PB25-0792, 1 Ocean Drive
2/3/2026 meeting "Exhibit A"

Objections and Protests to Application PB25-0792

Stearns Weaver Miller for Penrod Bros. Inc.

Date: January 5, 2026
Prepared by: Arturo G. Griego, G3 AEC
Subject: Analysis of Modifications and Non-Conformance in Recently Submitted Project Plans Compared to the Authorized Proposal
To: Maria A. Fehretdinov, Esq. Stearns Weaver Miller, for Penrod Bros. Inc.

5. PROPOSED PERVIOUS IMPERVIOUS

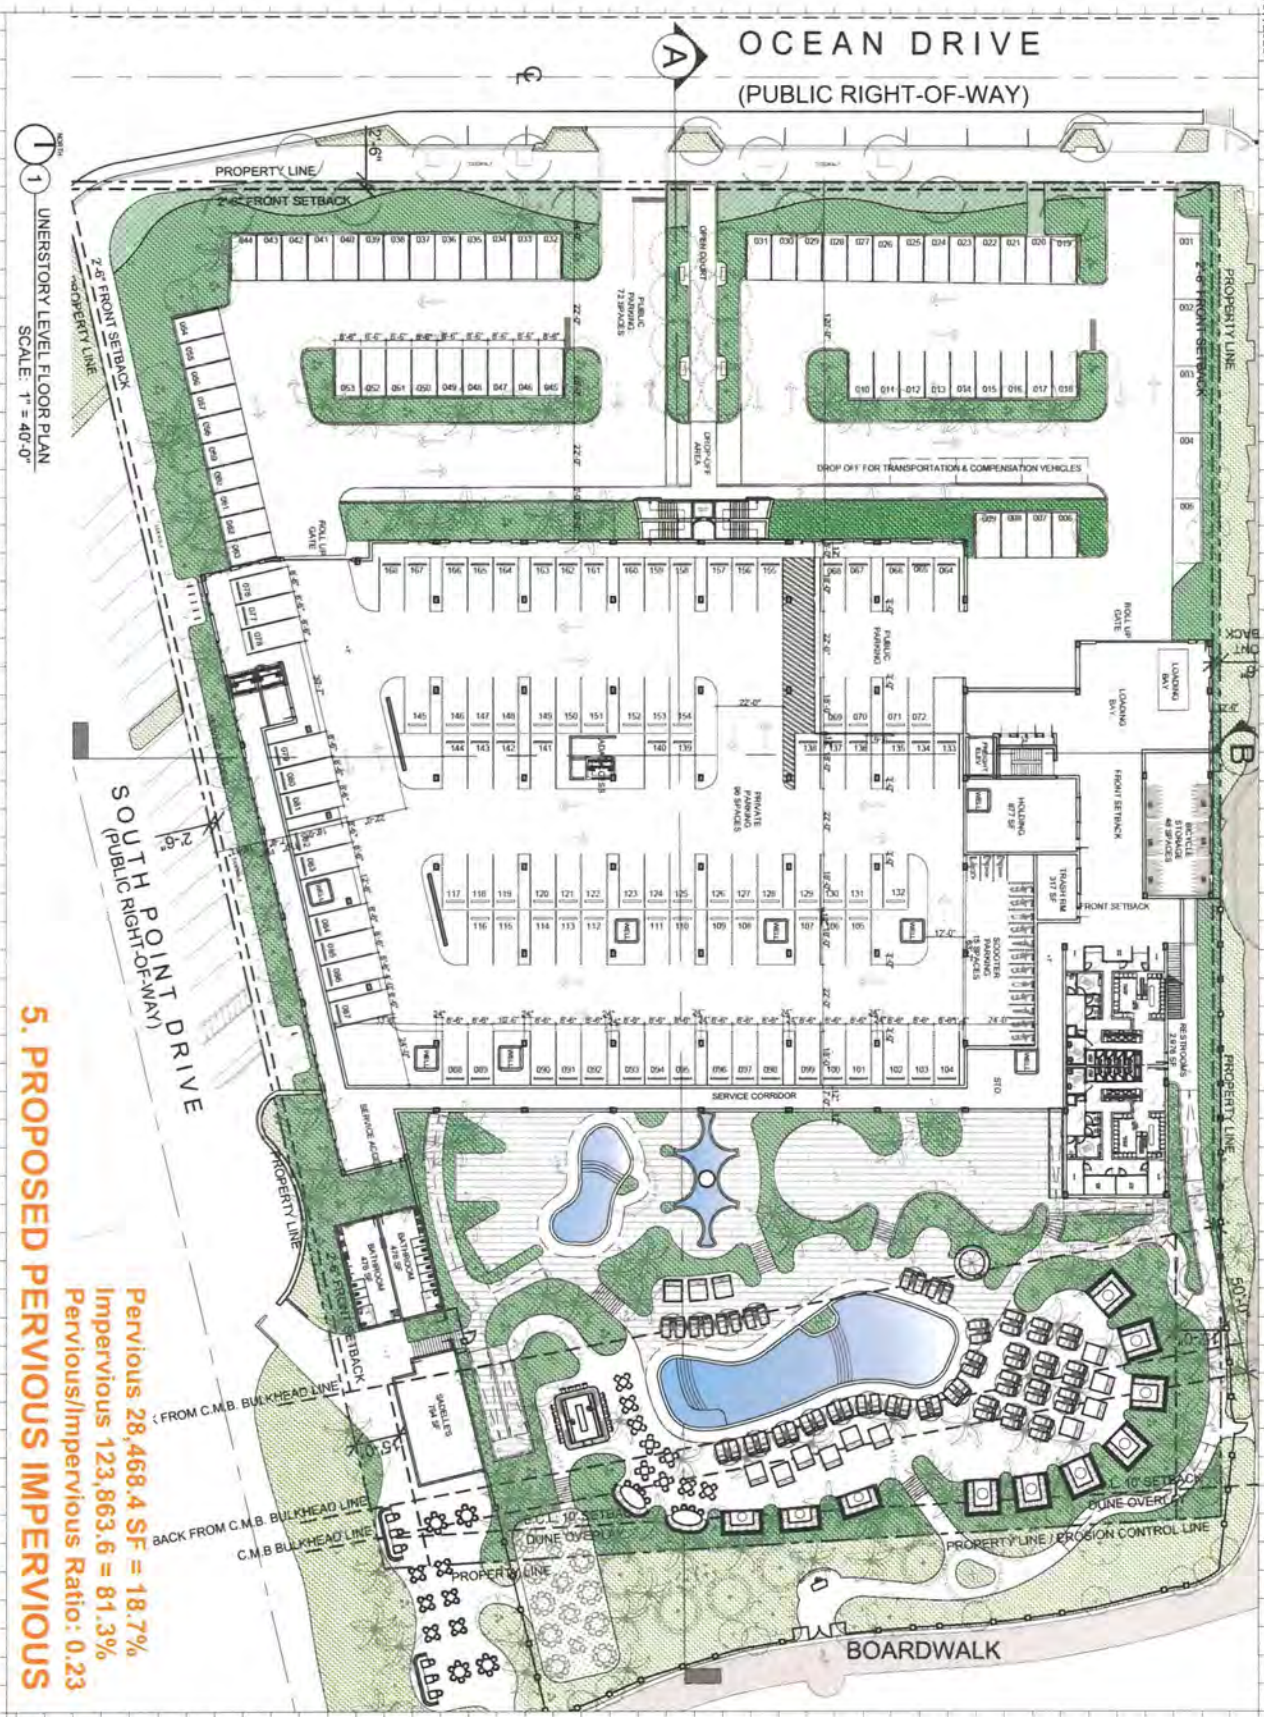
The balance of pervious (permeable) and impervious (non-permeable) areas has shifted markedly, again driven by the understory addition.

Impact: Likely increases impervious coverage, heightening risks of stormwater runoff and environmental impacts; to offset this, additional wells will be required

Quantified Difference: Original pervious/impervious: pervious **57,100.8 SF = 37.5%**, impervious **95,231.2 = 62.5%**
Recently Submitted: pervious **28,468.4 SF = 18.7%**, impervious **123,863.6 = 81.3%**; Key Shift: **18.8%** of additional impervious area.

UNDERSUBSTORY LEVEL OVERALL FLOOR PLAN

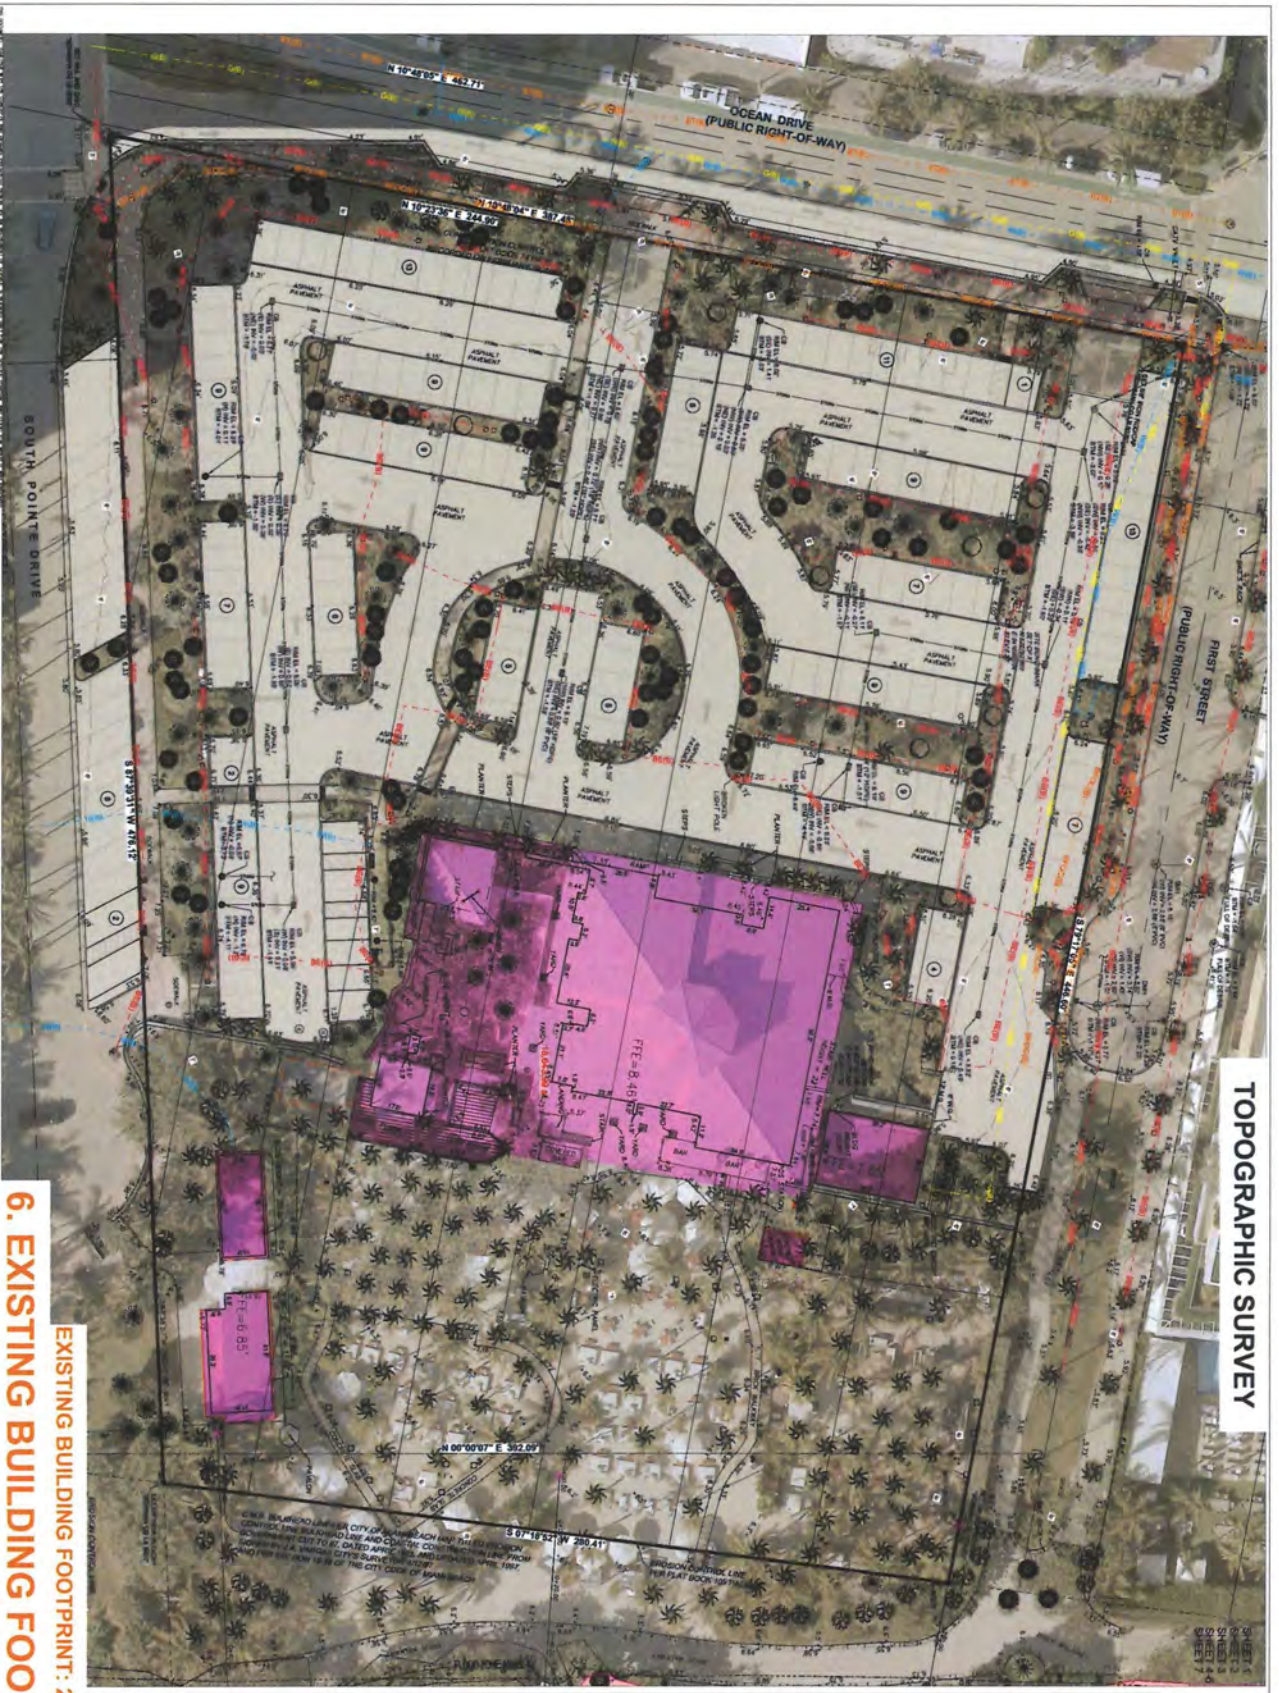
The recently submitted plan introduces a new understory level, absent in the original proposal, dedicated to parking, storage, and other usable spaces. This addition substantially increases the gross construction area beyond the reported FAR figures.

Impact: Represents a major expansion in built volume and site utilization (highlighted in yellow on the referenced site plans, comprising the majority of the project footprint)

Quantified Difference: Estimated increase in gross construction area: **55,166.57SF**
